**CONTRACT NO. 2021-24  
CITY COUNCIL CHAMBERS UPGRADE PROJECT**

**ADDENDUM NO. 2**

TA7.1

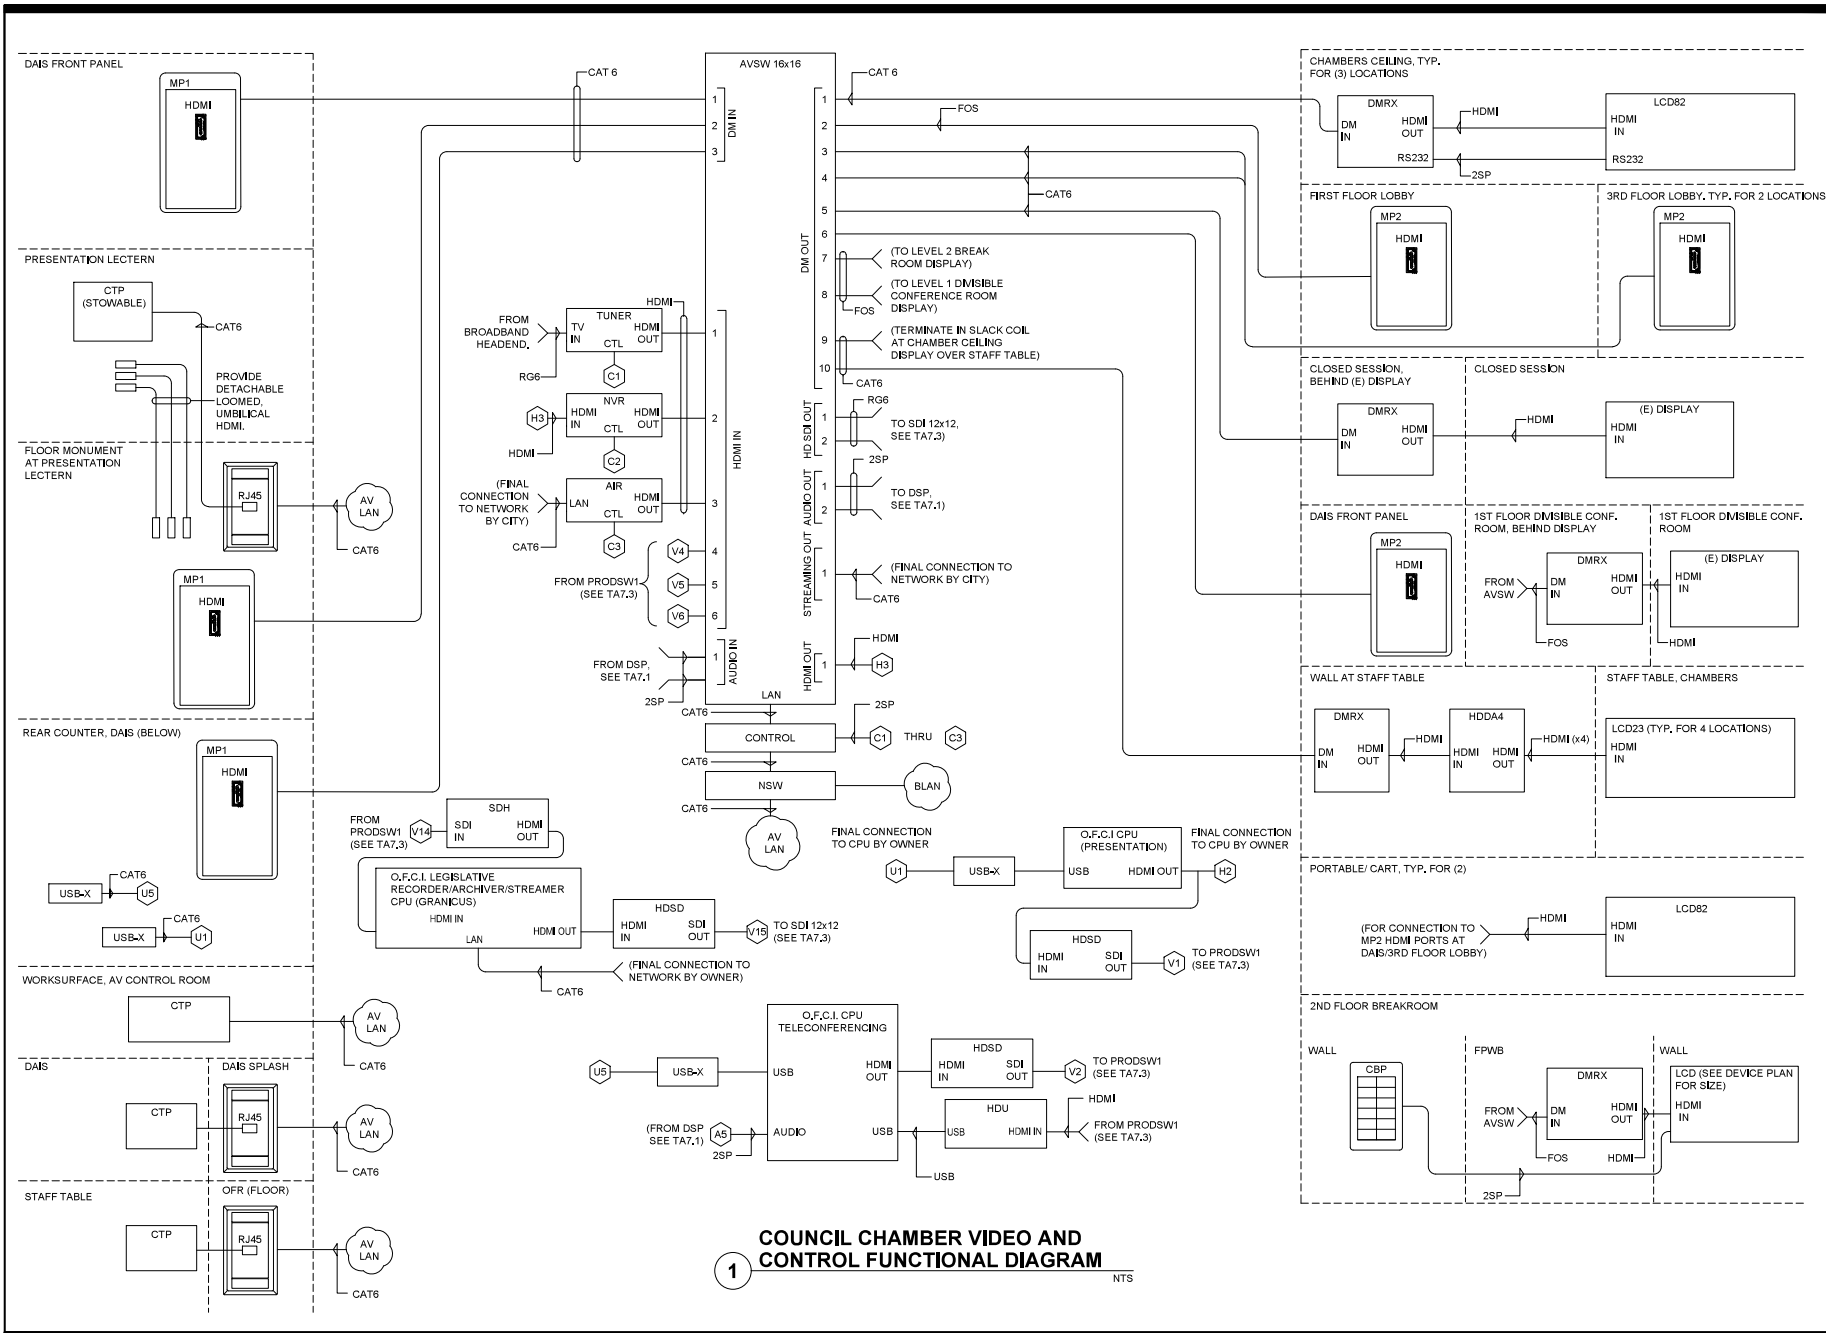
**Plan Sheet TA7.1** – ‘Additive Bid Alt #1’ on sheet TA7.1 of the City Council Chambers Upgrade Project Plans, is part of the base scope and there are no additive alternatives in the bid. Please see attached updated plans.
